PUBLIC INTEREST REVIEW FOR GROUNDWATER APPLICATIONS

SUBJECT: Application G- 18001 Supersedes review of na
Date of Review(s)

A. GENERAL INFORMATION: Applicant's Name: Andrew and Renee Angstrom County: Marion

Water Level Trends

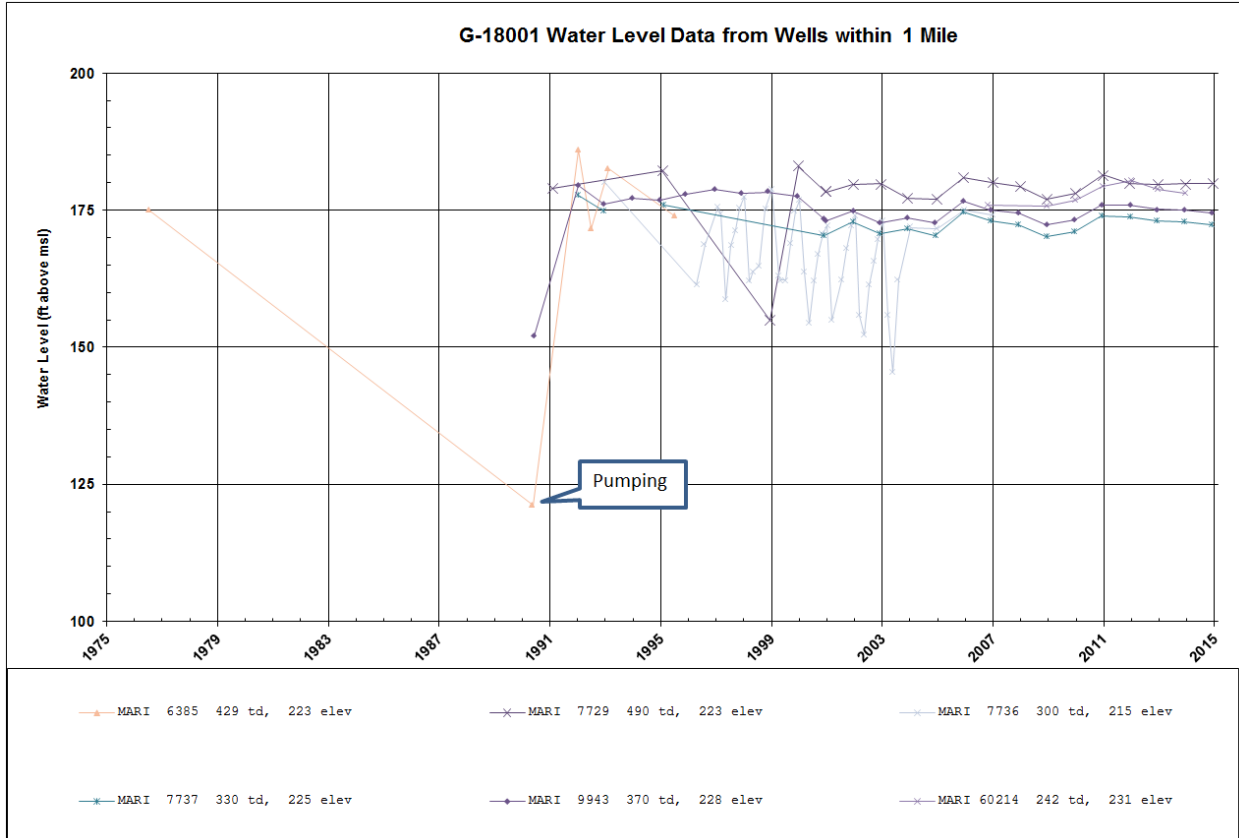
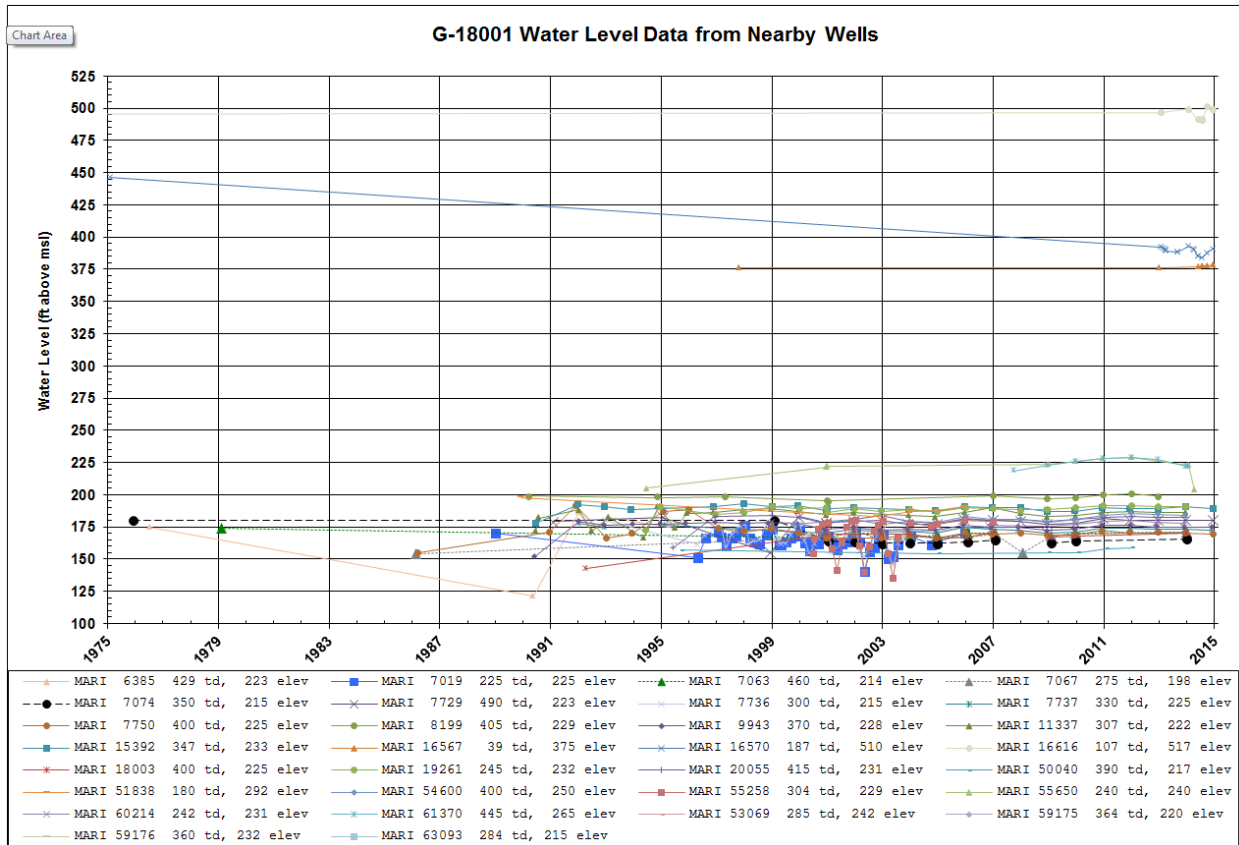
Ground water elevations in the area suggest the water-bearing zone in the applicant's wells may be shared by other groundwater users (see attached hydrographs). Long term trends indicate relatively stable water levels in the immediate area (within 2 miles), with no significant losses in head within the CRBG aquifers at the current level of use. Because the aquifers are confined (storativity is estimated to be 0.0001), pumping impacts will propagate outward at rapid rates and are likely to reach aquifer boundaries (streams, faults, and truncated basalt flow margins) within a few minutes. Using aquifer parameters appropriate for the basalts, it can be shown that the cone of depression from a pumped well will produce measureable impacts at a distance of 1 mile within several hours. Therefore, hydraulic interference with nearby wells, springs, and streams will occur rapidly once pumping begins if nearby streams and wells are connected to the same aquifer that is open in the well.
